MEMORANDUM

To: Jenna Kay, Planner II/Shoreline Master Program Coordinator

Brent Davis, Wetland and Habitat Review Manager/Shoreline Administrator From:

REVISED Proposed Shoreline Map Amendments for Plas Newydd Farm Subject:

2020 Shoreline Master Program Update Plas Newydd Farm Shoreline Map Revisions Figure 3: Revised Shoreline Designations

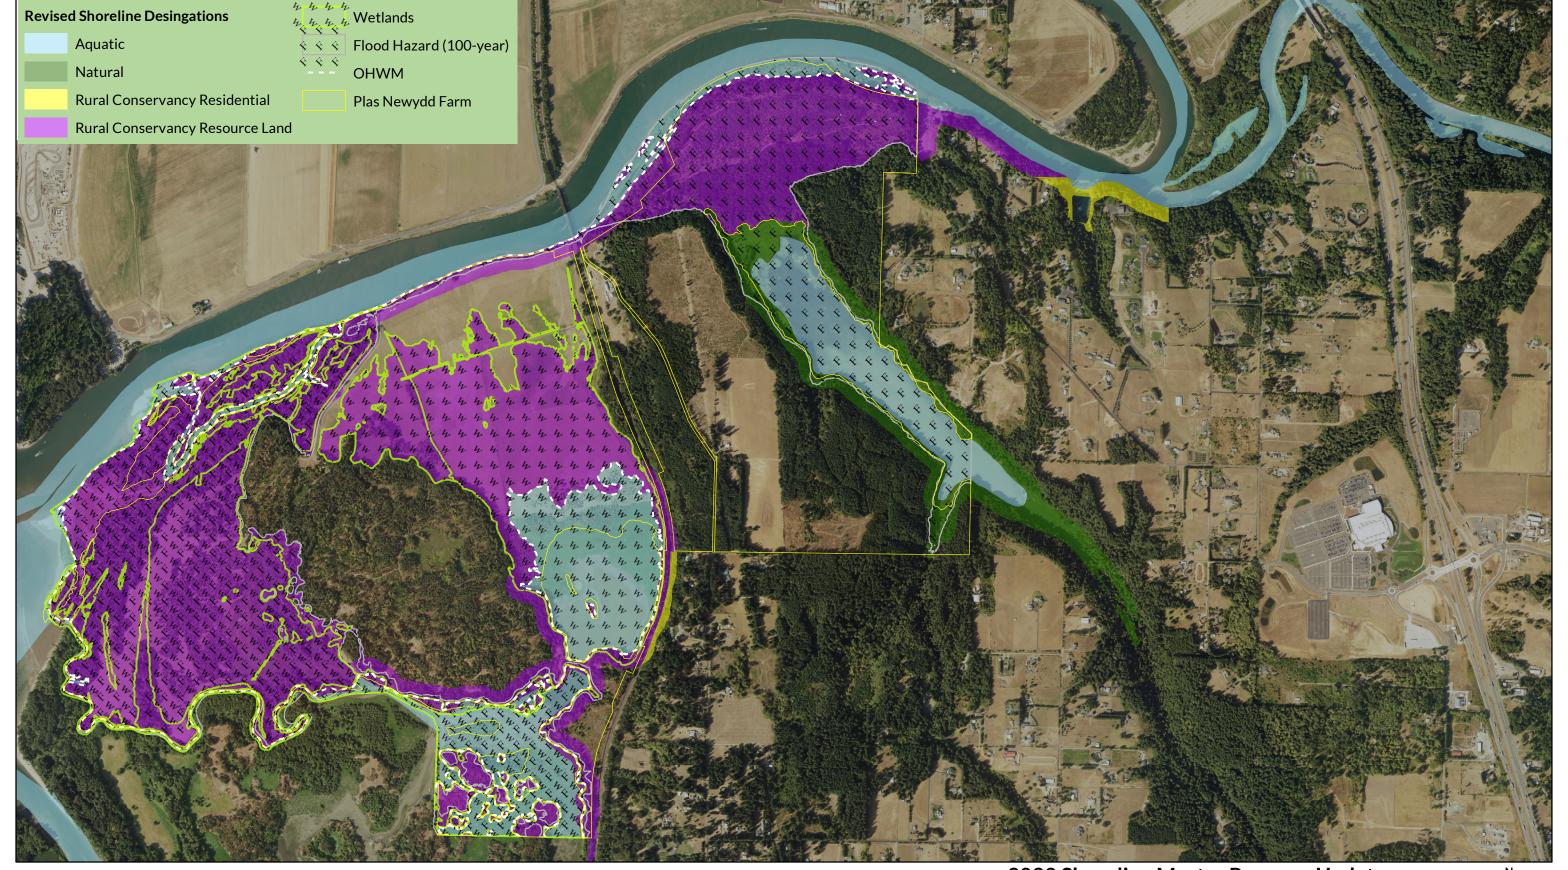
I have also processed the mapping data provided into an amendment of the Shoreline Management Area map for the site and attached a set of Figures that show where the data warrants removals and additions to the SMA as well as changes to the mapped Shoreline Designations based on the OWHM provided.
